Addendum No. 1

**For Project No. ENG2301725235
Electric Upgrade--Campground
Clifty Falls State Park
Jefferson County**

ISSUE DATE: April 11, 2024

ASPHALT PAVEMENT SECTION
NOT TO SCALE

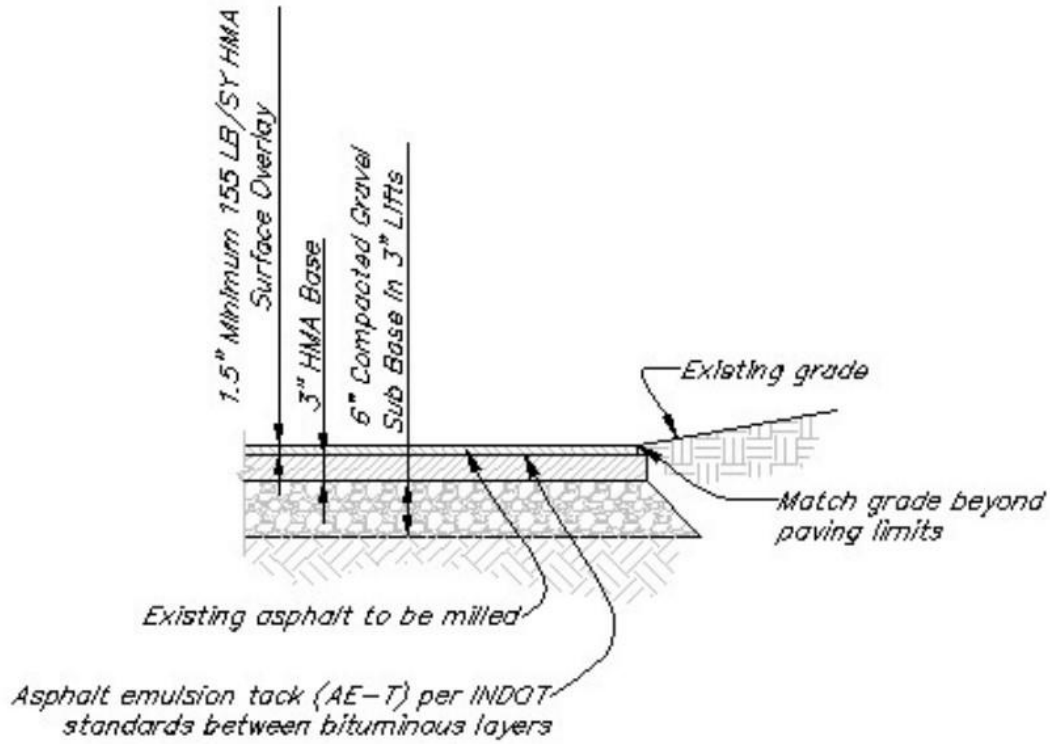
ITEM No. 1: Asphalt Pavement—Alternate #2 and Alternate #3.

Pavement for non-ADA compliant parking spurs.

Contractor is NOT repaving the entire campground.

The pavement for the spurs consists of the following:

- A. 6” of compacted #53 Stone in 3” Lifts**
- B. 3” of HMA Base**
- C. Asphalt emulsion tack (AE-T) per INDOT standards between bituminous layers.**
- D. 1.5” Minimum 155LB/SY HMA surface overlay.**
